GROUP BOD	MODEL 2018MY Niro (DE, DE PHEV)
	NUMBER 195	DATE September 2019
TECHNICAL SERVICE BULLETIN		
SUBJECT: SERVICE ACTION: TAILGATE STRIKER AND OVER-SLAM ENHANCEMENT (SA399)

SERVICE ACTION: TAILGATE STRIKER AND OVER-SLAM ENHANCEMENT (SA399)

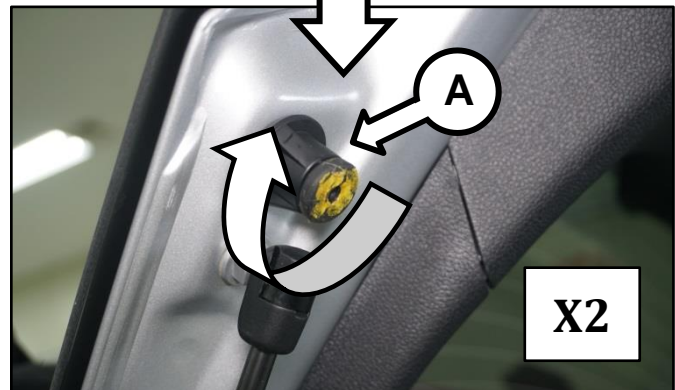
1. Locate the two (2) tailgate over-slam bumpers (A).

2. Fasten both of the over-slam bumpers (A) by turning each clockwise until hand tight.

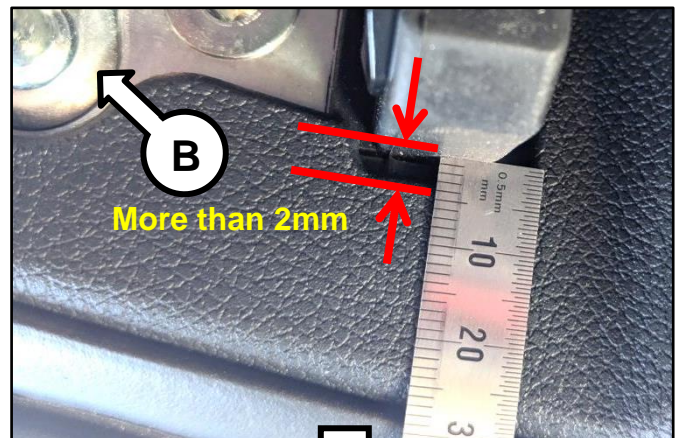
3. Locate the tailgate striker (B). Using a ruler, measure the gap between the rubber stopper and transverse cover as shown. The measurement should not exceed 2mm (0.079 inches).

If the measurement is not 2mm, proceed to the next step.

If the measurement is 2mm, proceed to step 5 to adjust the over-slam bumpers.

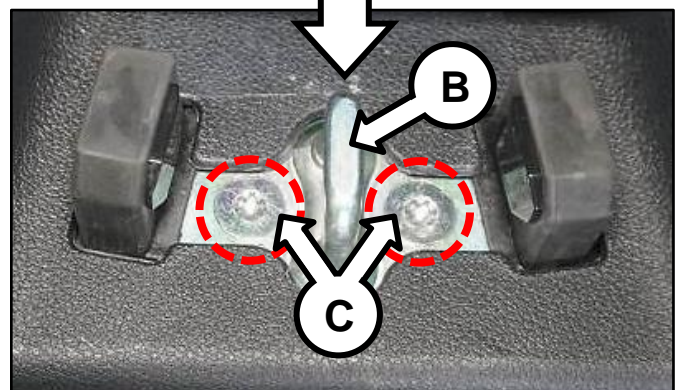
4. Loosen; do not remove the two (2) tailgate striker bolts (C) (approximately five (5) full turns).

Torque specification for bolt C (x2):
 4.85lb.m - 5.95lb.m (2.2kgf.m - 2.7kgf.m)

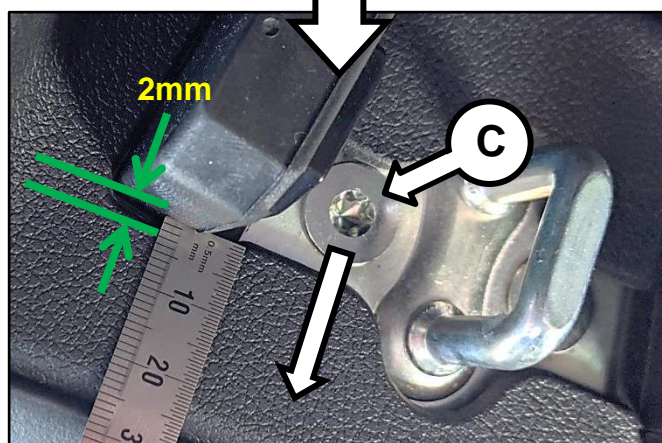
- 5a. Using a tool such as the striker adjusting fixture/slide hammer, adjust the tailgate striker (B) to the 2mm (0.079 in.) gap.

NOTE: If a striker adjusting fixture is not available, you may also use a soft plastic/rubber mallet to lightly tap and move the striker in the direction needed.

- 5b. Torque specification for bolts C:
15.91 – 19.53 lb.ft (21.57 – 26.48 N.m,
2.2kgf.m - 2.7kgf.m)

5. Adjust the two (2) over-slam bumpers by turning each bumper counter-clockwise to the 25mm length as shown.
